# Product Change Notification

**Product Change Notification:** P-26-030317

2POS MQS REC SEALED COD A

**New Mass Relief Identification**

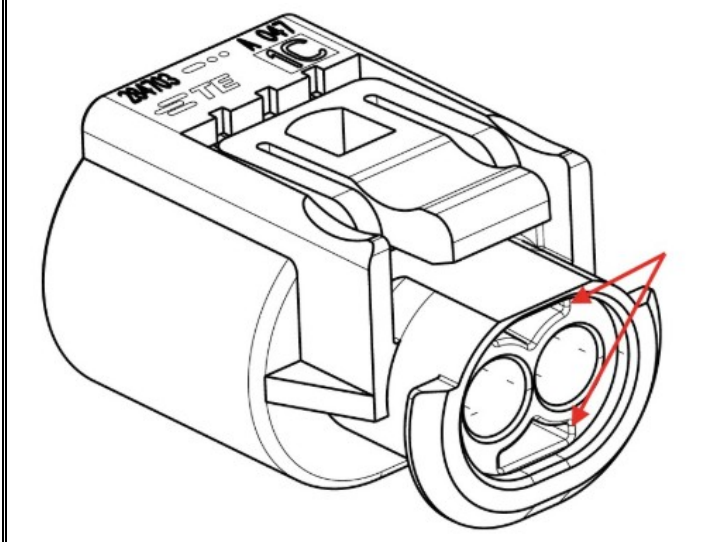
This PCN is the same as P-26-029622 and is being generated again due to an internal system issue and contains the same following text. This modification will be applied only to TE Brazil customers. Dear customer, as a result of our ongoing efforts to improve our processes, we are informing you about the improvement made. We will be implementing a new mass relief in the connector used for assembly 284703-1. The new method is carried out following a strict procedure that ensures there is no negative impact on the quality, supply capability, or functionality of the products involved. After receiving this notification, the PPAP and samples must be requested through the ePPAP system within 10 days. If you do not make the request in ePPAP, TE will understand and assume that this change has been accepted.

During the Mold Replacement process, the opportunity to implement a mass relief was identified. After approval of all required tests, the modification will be implemented following the completion of the mold replacement.
